Please Read	C	ITY OF	PORT			PERMIT	ISSUED
Application And Notes, If Any, Attached		P	ERMI		Permit Nur	nber: 07038	7
This is to certify that_	SMITH STEPHEN A	& ELIS A SMIT	H ITS/TBD			7.00	200000
as permission to	Change of use from 2	family single fa	y - M. ye kitche	1 1/2 beths	and make	HTY OF	PORTLAND
AT 13 DEERING ST	Ţ.			046 BO			
	Works for street line ure of work requires	h fication g handw b re this	inspe in mu in permit on pro- ding or it ther osed-li	CL CL	procured b		pancy must be efore this build-
OTHER REQ	UIRED APPROVALS	H JR NOT	IOE 15 NEQUIRED		-/		No las
leaith Dept.			Carlo San		///		2/0/01
ppeal Board				1/	YK	·/L	
Other	sartifient Name			1	france de	ing & insulaction Se	
04		ENALTY FOR	REMOVINGTH	IIS CARD	- Jan	3

City of Portland, Main 389 Congress Street, 0410	Permit No: 07-0381	Date Applied For: 04/10/2007	CBL: 046 B021001			
Location of Construction: 13 DEERING ST	Owner Name: SMITH STEPHEN A & E		wner Address: 3 DEERING ST		Phone:	
Business Name:	Contractor Name [*] TBD	Co			Phone	
Lessee/Buyer's Name	Phone:		ermit Type: Change of Use -	Dwellings		
	e of use from 2 family to single and make interior renovations	Change	Project Description of use from 2 fai se i

Proposed 2-hour Rated Demising Wall in Attic

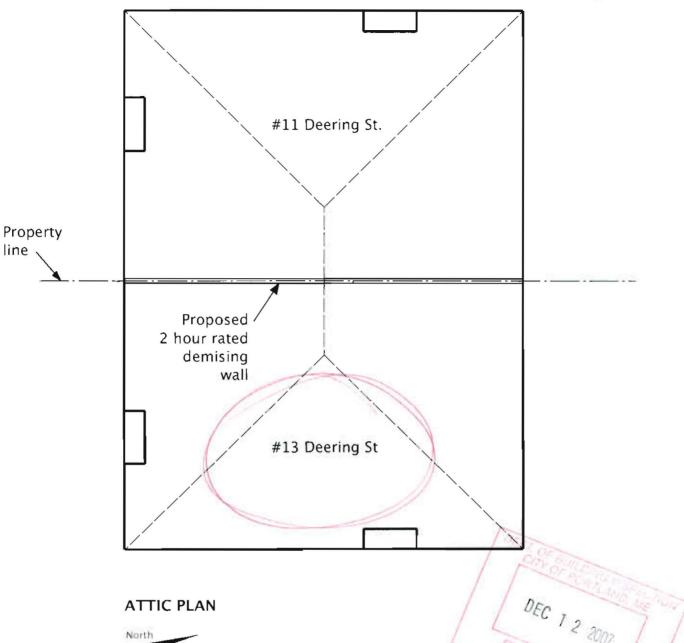
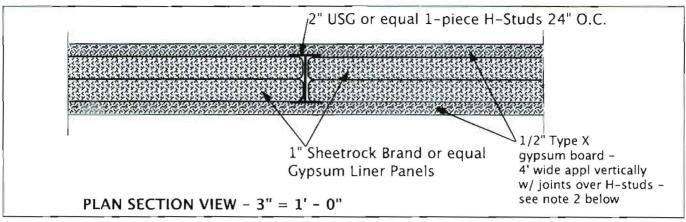
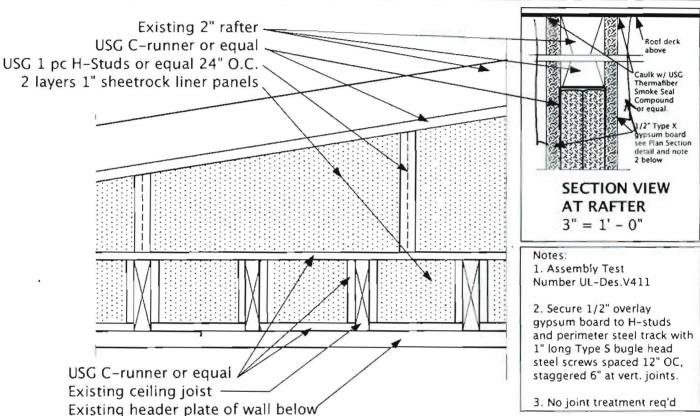
10/16/07 - Close-in incr Flech. O.K. Plumbing. O.K. Framing O.K. A Need to Add fixe wall in attic, to continue Brich A Add fire Blocking misch avecin 13 span in Duning Rome 2/2×12 to wide. Will ad col. 8-1 Max Spon 8-1 12/21/07 Not quite ready for Own poncey - Appl. Not set. Handrails. Temp - Posible - 12/20/07 11/12/08 - Final Tripection -All items addressed Close -out wow - End Oldy. CA
